MELFA Technical News

Subject: Change the shape of NO1 arm cover B**Applicable to: RV-4FL/FRL series**

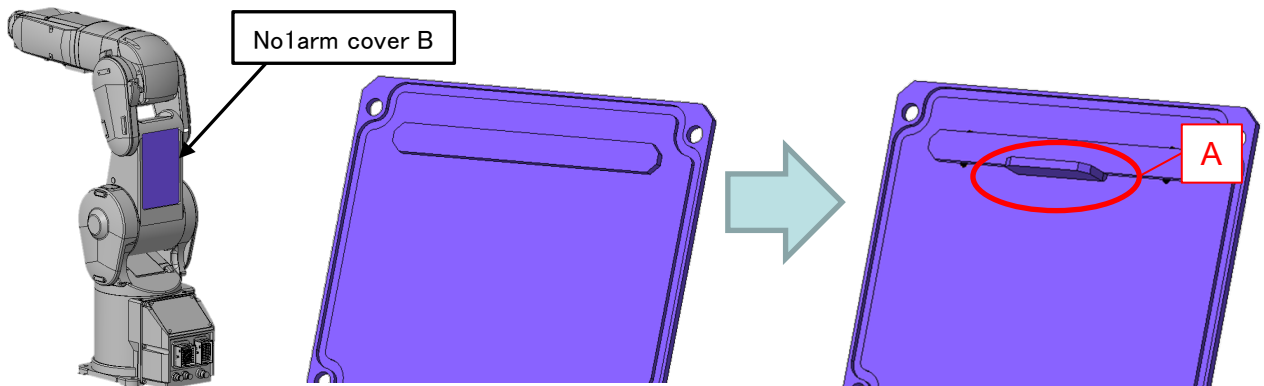
Change the shape of No1arm cover B as shown below.

This change will not affect the performance or functionality of the product.

Add a shape to support the heat conductive sheet pressed by NO1 arm cover B so that it will not fall off.

Attach the convex shape of part “A” in the above figure so that it slips under the heat conductive sheet.
